Access Compliance Report

Public Rights-of-Way

Intersection ID: 47575	Main Street: GLENBURN_LN	Cross Street: GAILES_DR	Location: SW
ADA ID: DCCC54C791CD	Ramp Type: PerpDiag	Initial Pass/Fail: Fail	Overall Compliance: No
Severity Score: 37.5			
Codes/Mitigation Info/Possible Solution		Field Measurements/Component Compliance

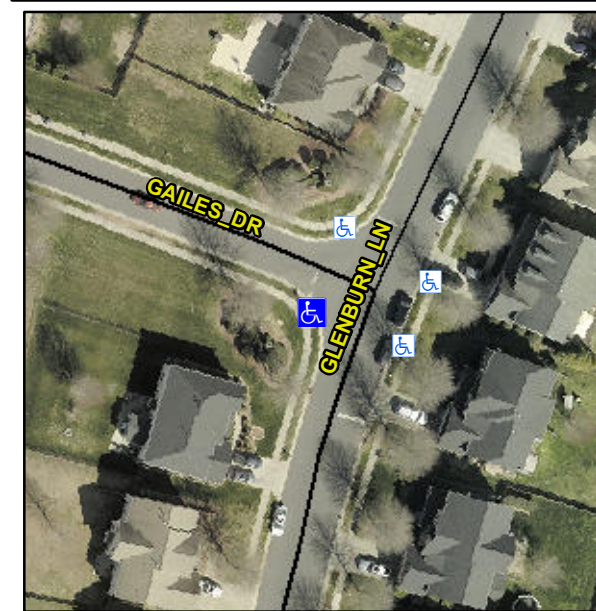
Not Found, R304.2.2, R304.5.3

Compliance	Description	Data	Compliance	Description	Data
N/A	Ramp Length (in)	45.0	No	Ramp Slope (%)	8.7
Yes	Ramp Width (in)	48.0	No	Ramp XSlope (%)	8.1
N/A	Flare Type LT	N/A	N/A	Flare Type RT	N/A
N/A	Flare Slope LT (%)	N/A	N/A	Flare Slope RT (%)	N/A
N/A	Flare Traversable LT?	N/A	N/A	Flare Traversable RT?	N/A
N/A	Landing Length (in)	N/A	N/A	DWS Provided?	N/A
N/A	Landing Width (in)	N/A	N/A	DWS Contrast?	N/A
N/A	Landing Slope (%)	N/A	N/A	DWS Length (in)	N/A
N/A	Landing X Slope (%)	N/A	N/A	DWS Full Width?	N/A
N/A	Landing Curb? (Y/N)	N/A	N/A	DWS Offset (in)	N/A
N/A	Shared Landing?	N/A			
N/A	Gutter Ponding?	N/A	N/A	Gutter Slope (%)	N/A
N/A	Gutter Lip Ht (in)	N/A	N/A	Gutter X Slope (%)	N/A
N/A	Painted X Walk1?	No	N/A	Painted X Walk2?	No
	X Walk 1 Direction	To SE		X Walk 2 Direction	To NE
N/A	X Walk 1 Width (in)	N/A	N/A	X Walk 2 Width (in)	N/A
	X Walk 1 Slope (%)	3.5		X Walk 2 Slope (%)	6.0
	X Walk 1 X Slope (%)	6.2		X Walk 2 X Slope (%)	3.2

Remove & Replace Curb Ramp With Two New Directional Ramps or Equivalent.
